**A RESOLUTION BY THE CITY TO ACCEPT A BID BY BROTHERS
CONSTRUCTION, INC. FOR THE DOWNTOWN REHAB PROJECT, PHASE 2A**

CHANGE ORDER NO. 01 For Contract between Owner and Contractor

Project Name: Downtown Bond Projects – Package 2A BMcD Project No. 128234
Owner: City of Prairie Grove, Arkansas Client Project No. --
Contractor: Brothers Construction, Inc. Contract No. --

CHANGE ORDER #1
SCOPE OF WORK EXHIBITS
ROADWAY AND DRAINAGE (BID SCHEDULE A)

BUCHANAN ST.
PLAN AND PROFILE - 1

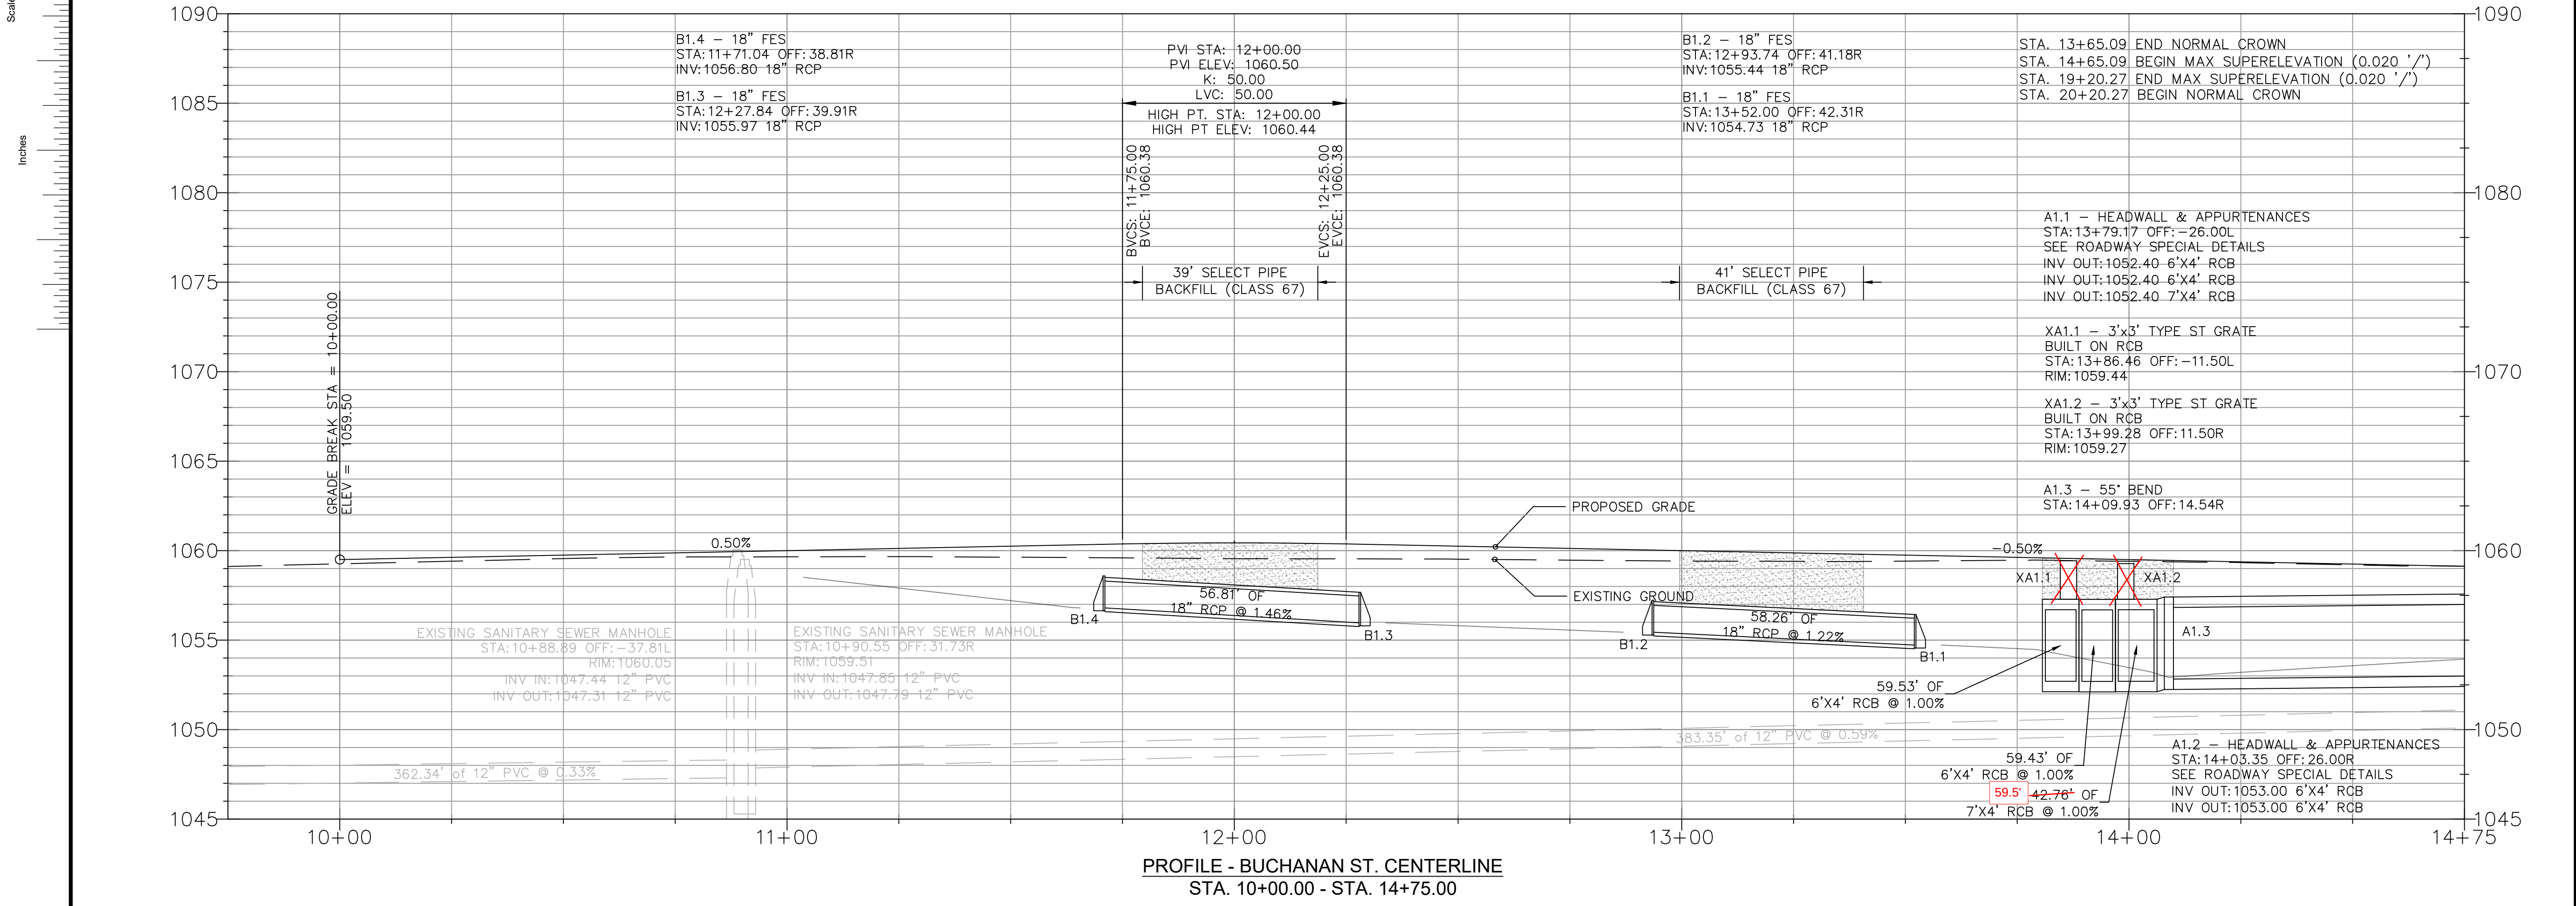
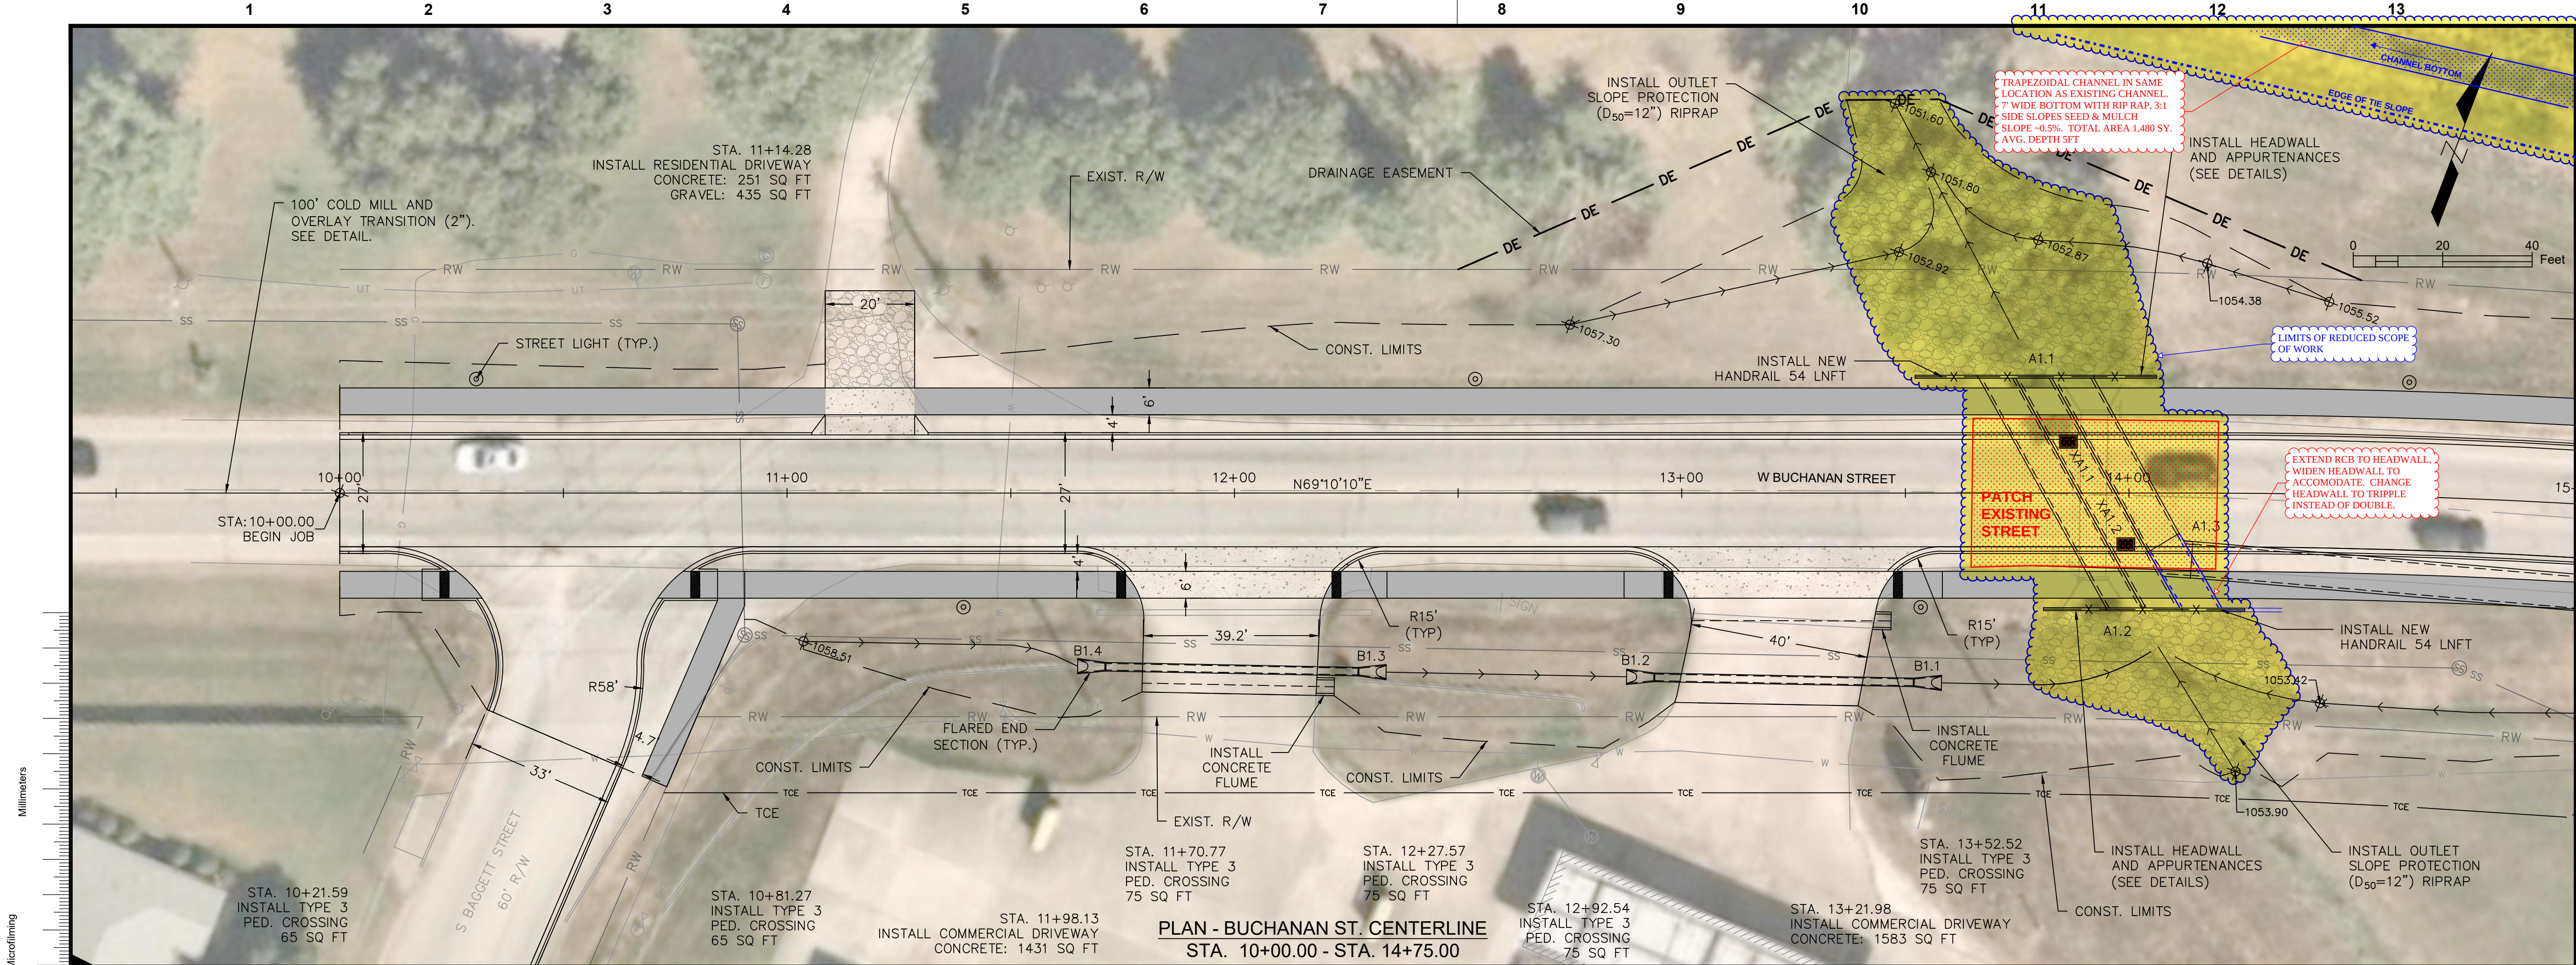
Roadway and Drainage Scope of Work (Bid Schedule A) shall be reduced to include only that work as highlighted in yellow on the attached Scope of Work Document. Generally, this includes:

- Drainage Improvements along W Buchanan Street from the existing creek – east to the intersection with Kate Smith Street
- Drainage Improvements along Kate Smith Street
- Roadway, Curb and Sidewalk improvements along the south side of Buchanan from Kate Smith Street, west 800 feet.
- Roadway and Curb Improvements along Kate Smith from Buchanan Street to Parks Street.
